Docket Number:	15-AAER-06
Project Title:	Small Diameter Directional LED Lamps and General Purpose LED Lamps
TN #:	209407
Document Title:	NEMA/Kyle Pitsor Comments: Comments on Proposed Amendments to Appliance Efficiency Regulations
Description:	N/A
Filer:	System
Organization:	NEMA/Kyle Pitsor
Submitter Role:	Public
Submission Date:	1/26/2016 8:12:26 AM
Docketed Date:	1/22/2016

**NEMA Comments on Proposed Amendments to Appliance Efficiency Regulations;
Revised 15-Day Language**

NEMA Comments on Proposed Amendments to Appliance Efficiency Regulations; Revised 15-Day Language

Figure 1: Comparison of R8 and R9 for 2700K products and 5000K Products

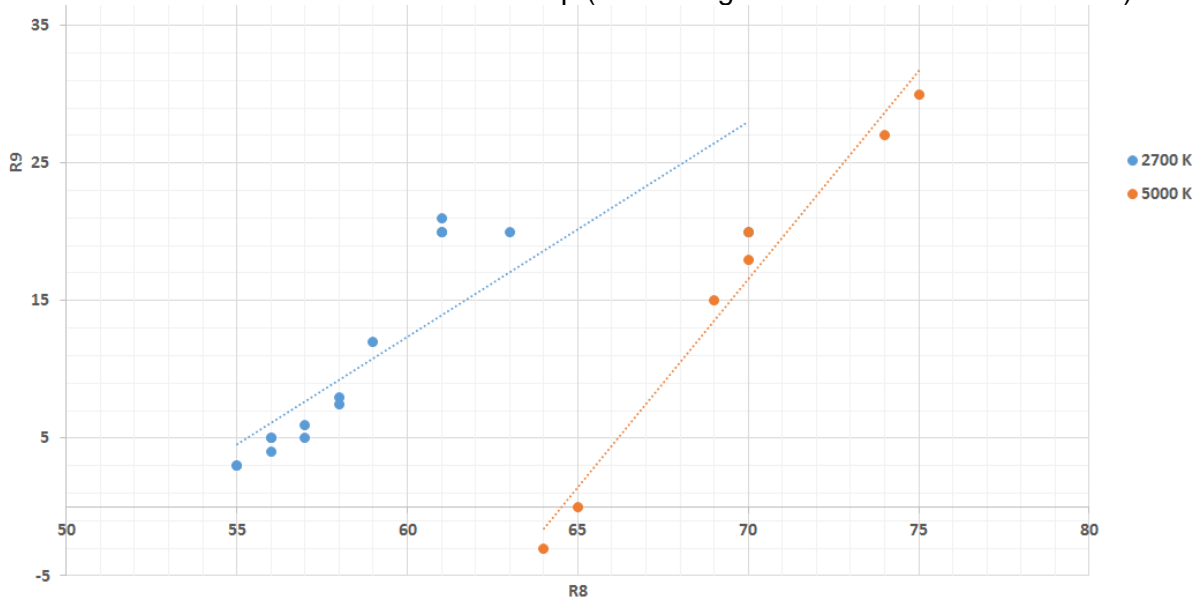
a) In follow up to our example in item 4 above, as we noted in our 45-day docket comments (footnote 1), efforts to justify the use of R9 as proxy for R8 is a significant technical error and inaccurate. As we demonstrated in our 45-day comments, R8 and R9 are related, but not directly proportional and perhaps more importantly they vary by color temperature (CCT). Setting overly burdensome R1-R8 score requirements will incentivize high-CCT lamps ($\geq 5000K$), which consumers will not prefer. The data submitted by Mr. McGaraghan (and repeated in the supplemental staff analysis issued on 12/28) does not include any distinction between high and low CCT for the lamps graphed, and again misleads the public into believing there is widespread product compliance across the typical range of choices demanded by consumers. There is not.

We again provide the following graph of R8 and R9 versus CCT as an illustration of the above described interrelationship (R values gathered from NEMA members):

d. In conclusion: NEMA again proposes that CEC respect and restore the global minimum of CRI 80 for LED lamps in California, and if the CEC will not abandon the unnecessary R1-R8 requirements we suggest at the very least that the R8 requirement be set at $R8 > 55$, leaving $R1-R7 > 72$. This will allow well-made, high quality CRI 80 products already selling in high volume to remain competitive available in the market and to serve as lower-cost alternatives when high color rendering is not needed. This will also help compete against CFLs, which are the
